Appendix J: Phase 1 Comments and Responses  
Attachments

CENSE would like the opportunity to dispute some of the “facts” stated by PSE representative Keri Pravitz before the Bellevue City Council on March 7, 2016.

# Load Flow modeling for "Energize Eastside"

Figure 4: PSE’s graph shows customer demand exceeding system capacity in 2018.<sup>2</sup>

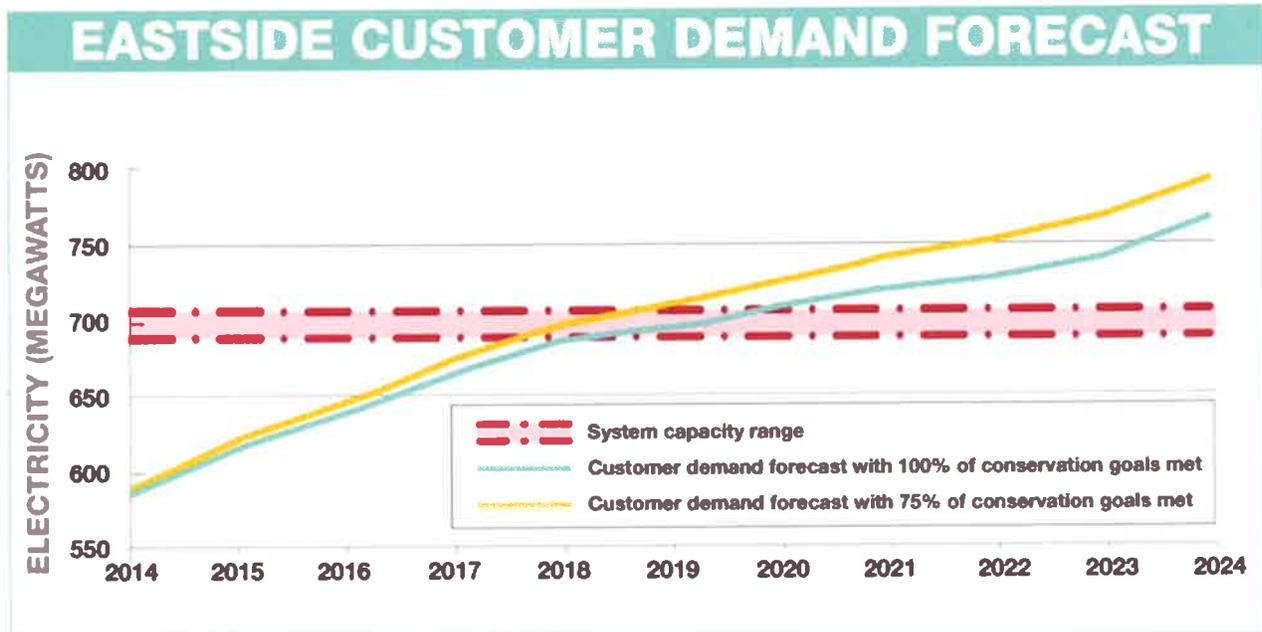
Concerns about future capacity are illustrated in Figure 5, PSE’s demand forecast graph.<sup>2</sup> This graph raises several questions. For example, it’s not clear how PSE determined the “System capacity range” of approximately 700 MW. If this value is derived from the transformer capacities listed in the WECC Base Case, these capacities are set to default values corresponding to “summer normal” conditions.

PSE’s graph shows Customer Demand growing at an average rate of 2.7% per year. However, data submitted by PSE to WECC shows a growth rate of only 0.5% per year. An explanation of this discrepancy is necessary to understand this graph.

Figure 3: PSE 2015 IRP Figure 5-21: Electric Peak Demand Forecast before DSR 2015 IRP Base Scenario versus 2013 IRP Base Scenario Hourly Annual Peak (23 Degrees, MW)

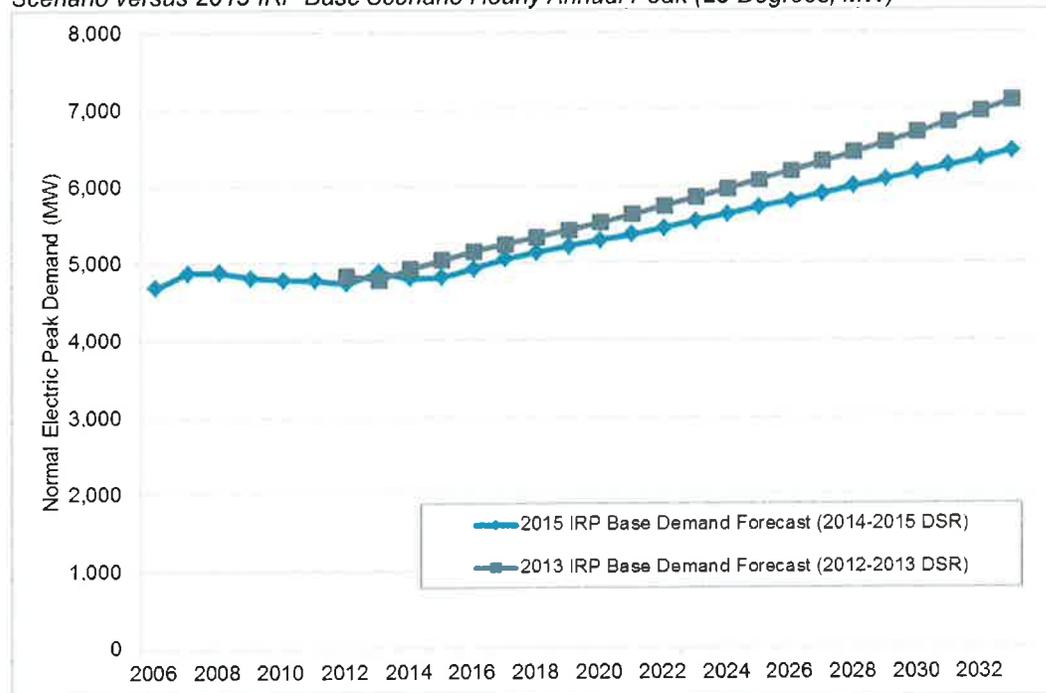
Figure 2 below shows how peak load is historically flat, then suddenly takes off in the future. You'll find this to be true with PSE's previous peak load forecasts. I understand that forecasts are, by their nature are wrong, but PSE has a habit of overestimating peak load.

Figure 5-27: Electric Peak Forecasts by County (MW), after applying 2013 IRP DSR

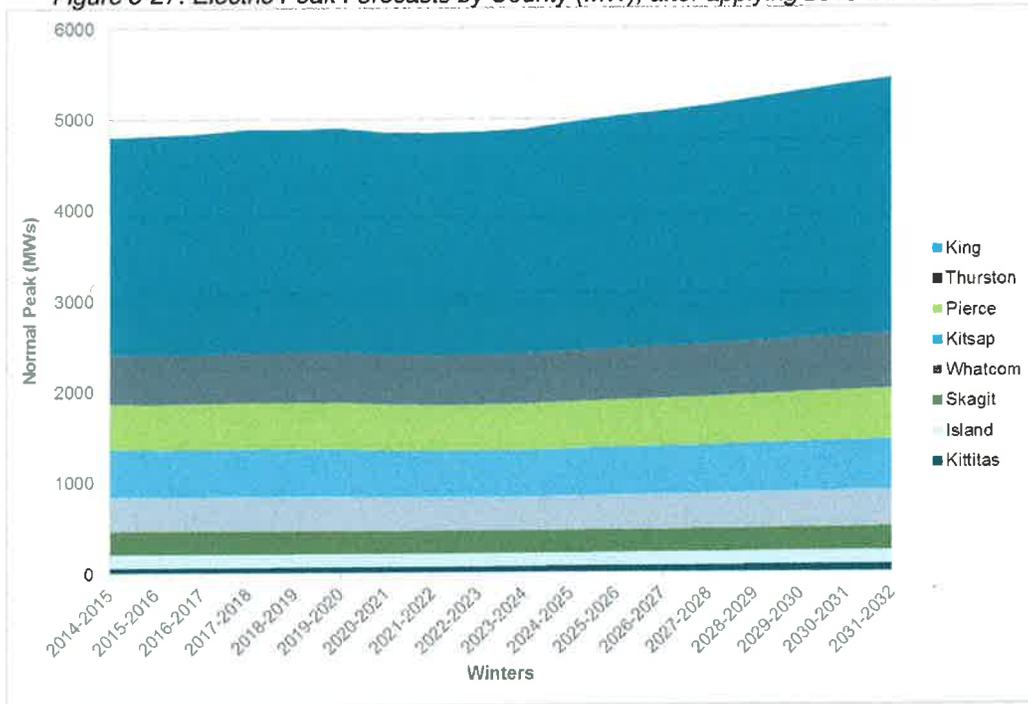
**Notice in Figure 5-27 from PSE's 2015 IRP, the peak demand does not begin to increase until 2024.**

Figure 3: PSE 2015 IRP *Figure 5-21: Electric Peak Demand Forecast before DSR 2015 IRP Base Scenario versus 2013 IRP Base Scenario Hourly Annual Peak (23 Degrees, MW)*

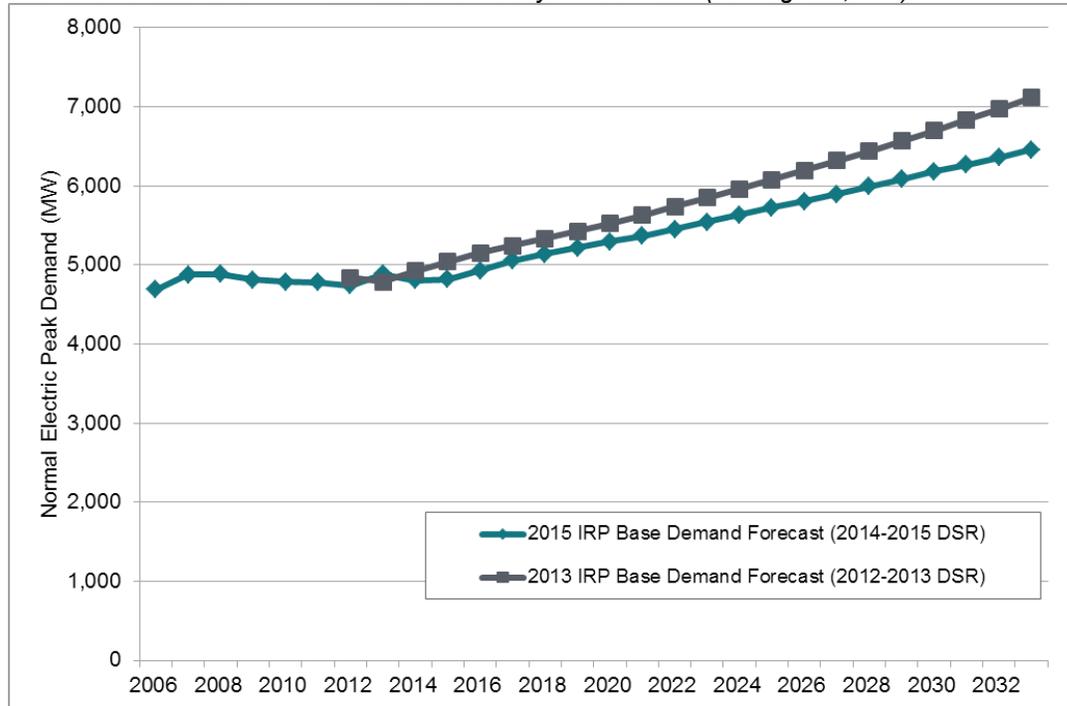
Figure 2 below shows how peak load is historically flat, then suddenly takes off in the future. You'll find this to be true with PSE's previous peak load forecasts. I understand that forecasts are, by their nature are wrong, but PSE has a habit of overestimating peak load.

Figure 5-27: Electric Peak Forecasts by County (MW), after applying 2013 IRP DSR

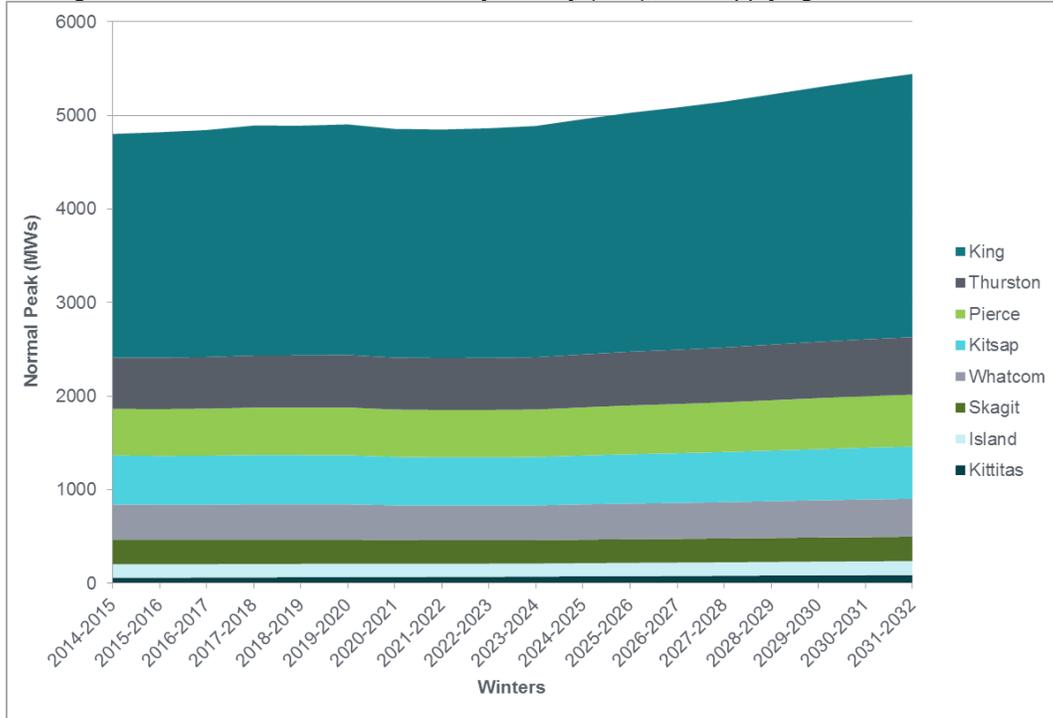
**Notice in Figure 5-27 from PSE's 2015 IRP, the peak demand does not begin to increase until 2024.**
